APPLICATION NO.	FILING DATE	FIRST NAMED INVENTOR	ATTORNEY DOCKET NO.	CONFIRMATION NO.
10/086,862	03/04/2002	Xuesong Chen	9351-97	9938

Office Action Summary

1. This application contains claims directed to the following patentably distinct species of the claimed invention:

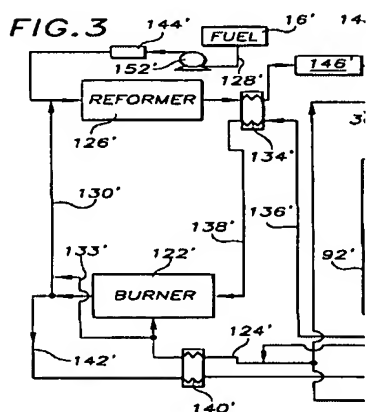
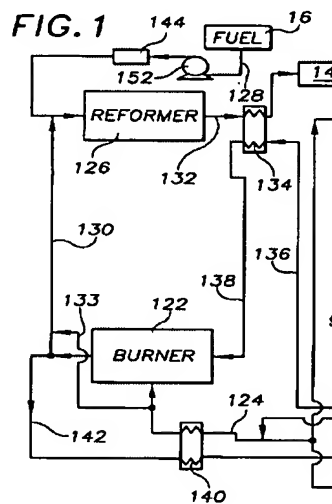
Figures 1 and 3 below shows that the burner 122 per se supplies an exhaust stream 130 to the reformer 132 which further process the fuel to be fed into the fuel cell.

Examiner's note: *As to the oxidant being supplied in an amount less than the stoichiometric amount required, the examiner asserts that even though the burner exhaust stream leaving the burner 122 might be combusted to be nonflammable, somehow, certain degree of combustion incompleteness may occur in the burner so as to leave any unused or uncombusted fuel (thus, there will be more fuel than oxidant in the system; and somehow, at least oxidant will be more consumed and after certain period of time oxidant supply will be deficient in amount with respect to the required combustion degree) in the burner exhaust which is then supplied to the reformer and thereafter to the fuel cell as reformed fuel. In that, it is pointed out that under normal operating conditions it is very unlikely that a full-complete (100 %) combustion takes place in the burner so as to totally and entirely burn or combust all the fuel*
